ADDENDUM 01

This addendum is considered to form part of the contract document issued for this Request for Quotation. Its content precedes previously issued documents in case of conflicting information.

M-206

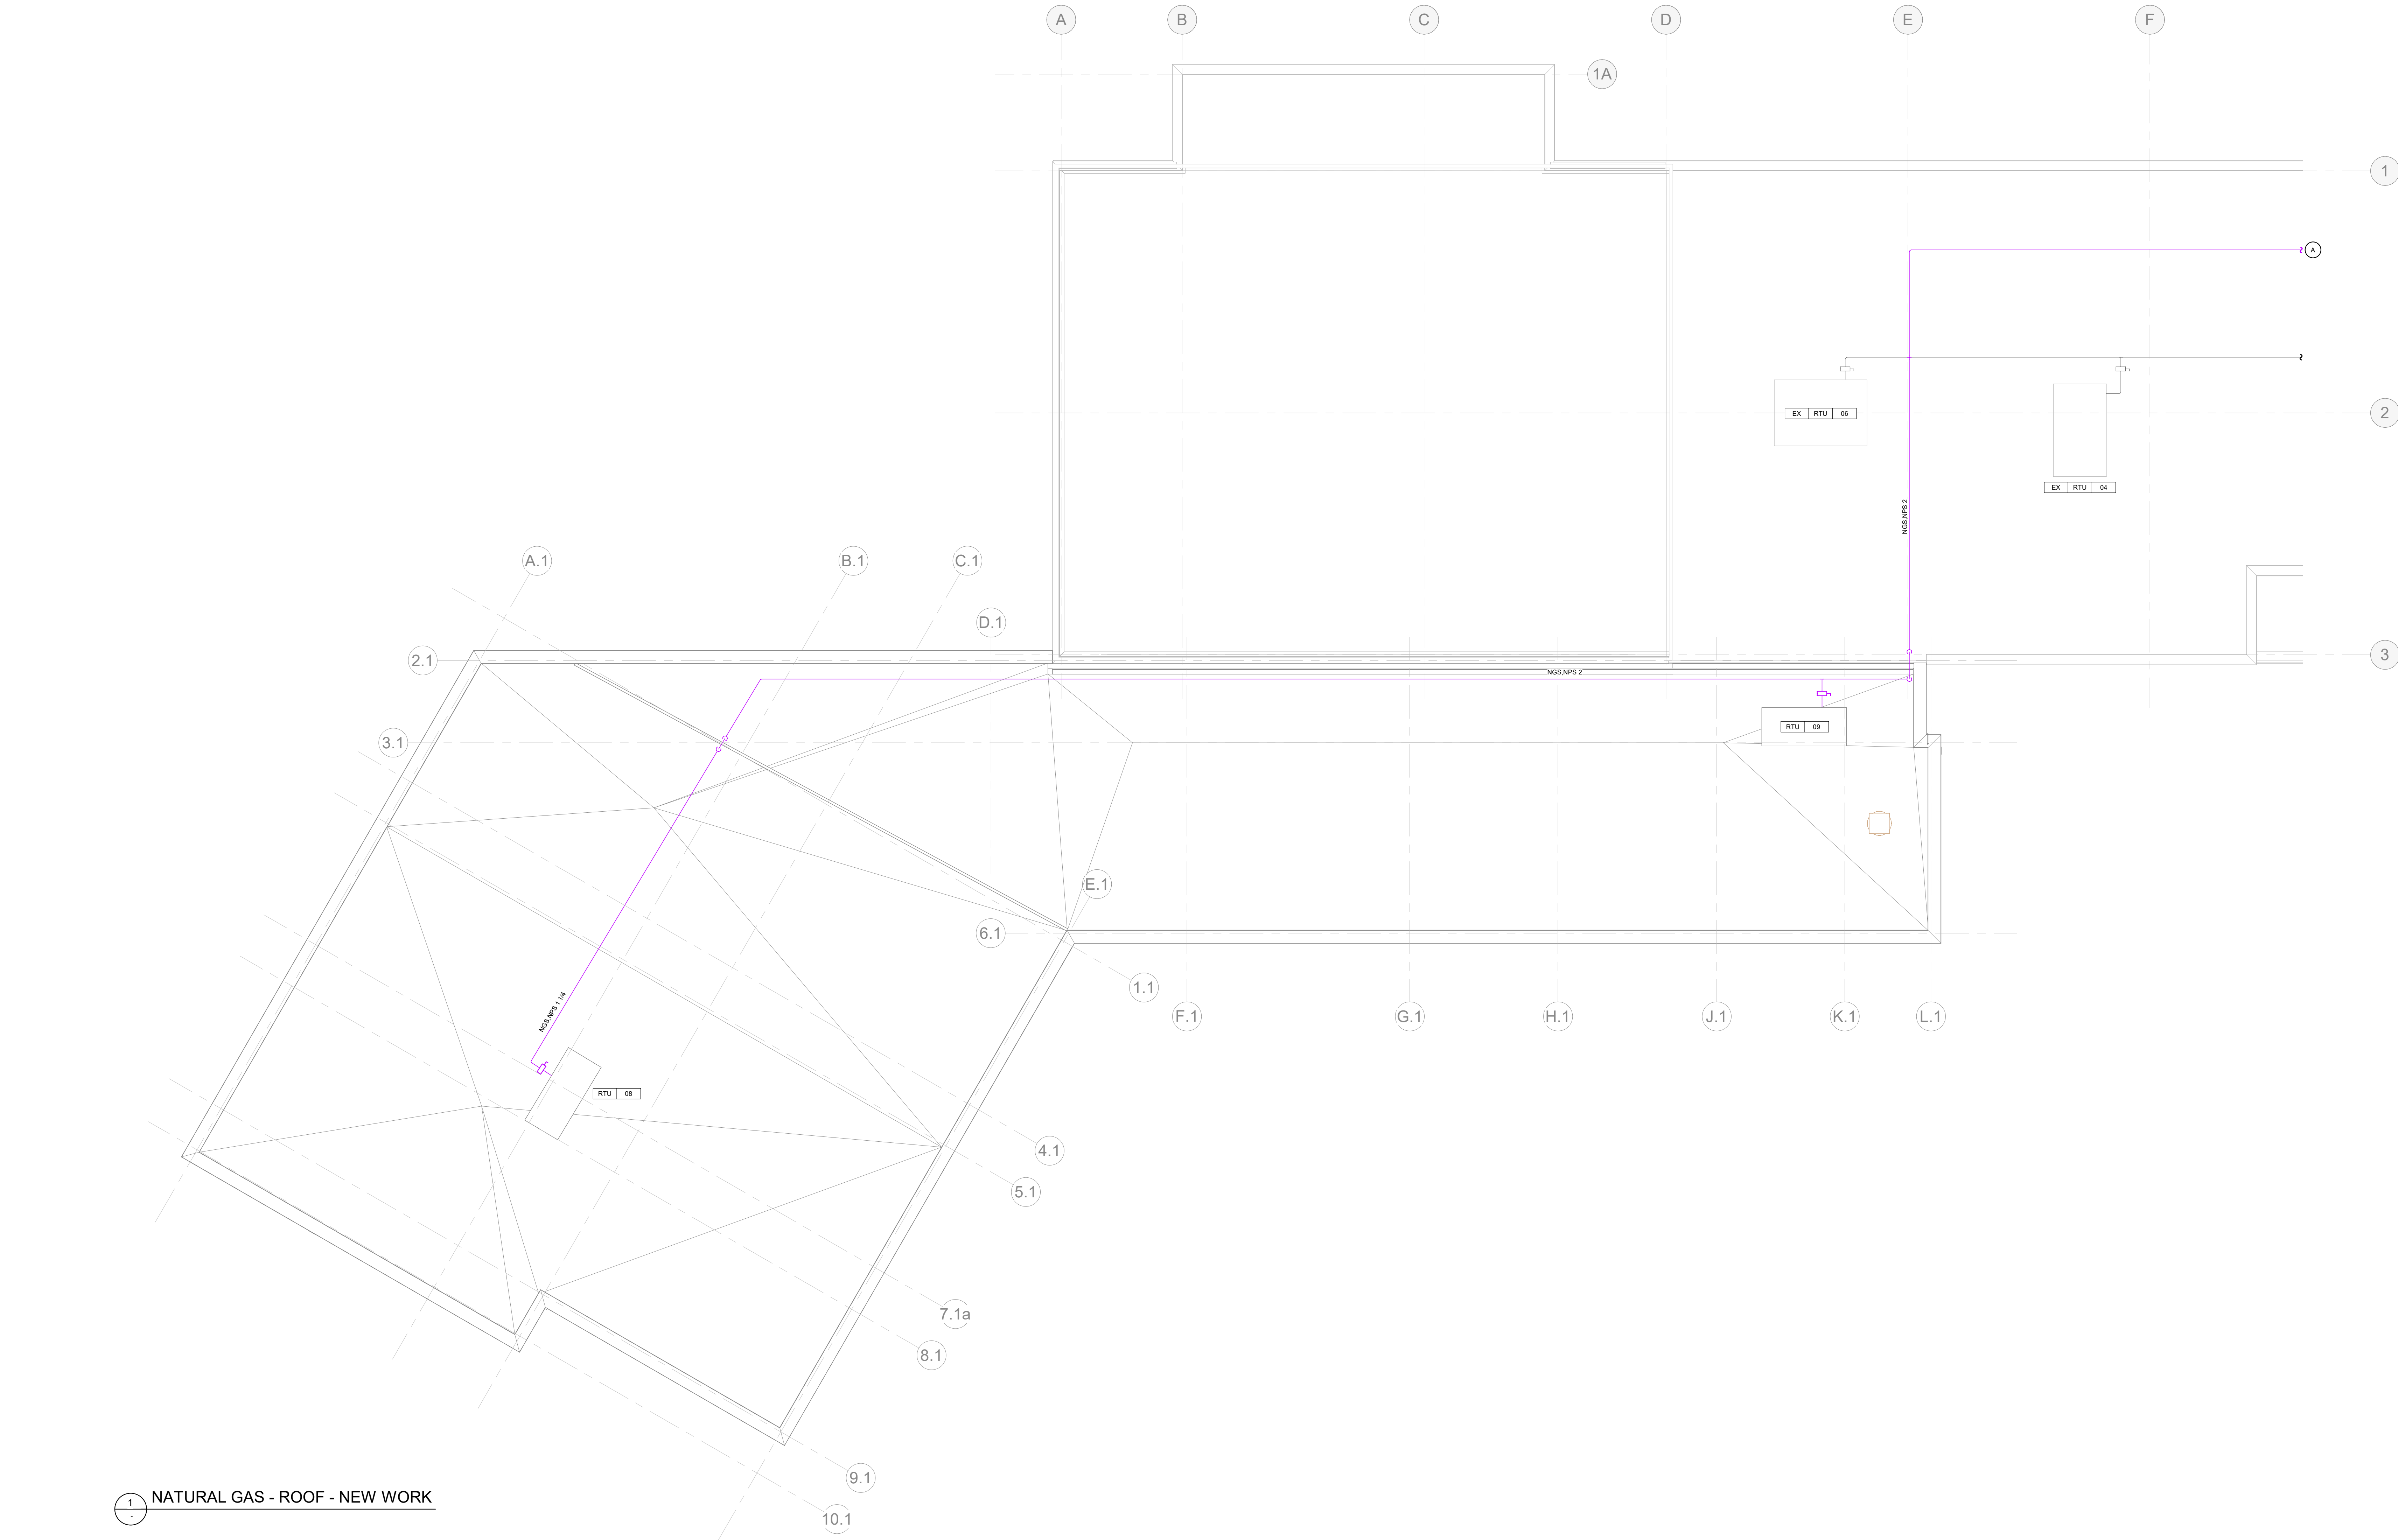
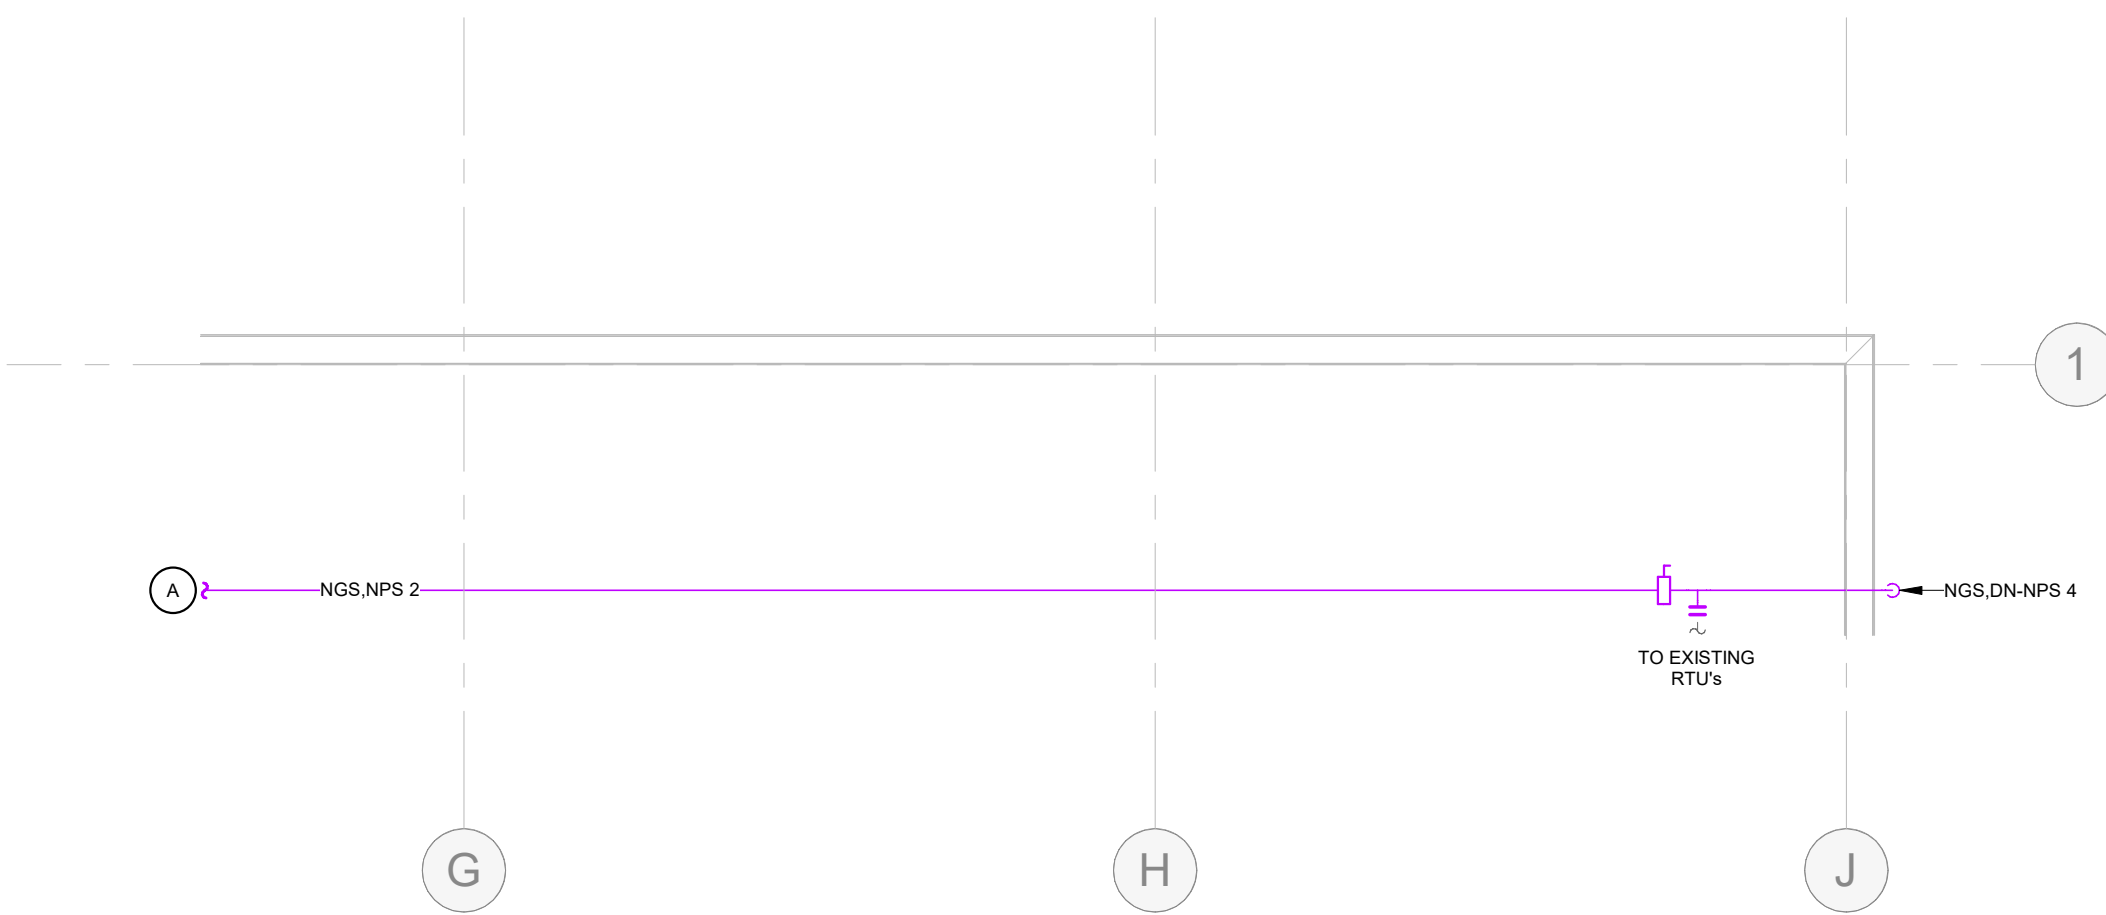
2.3 Drawing M-206
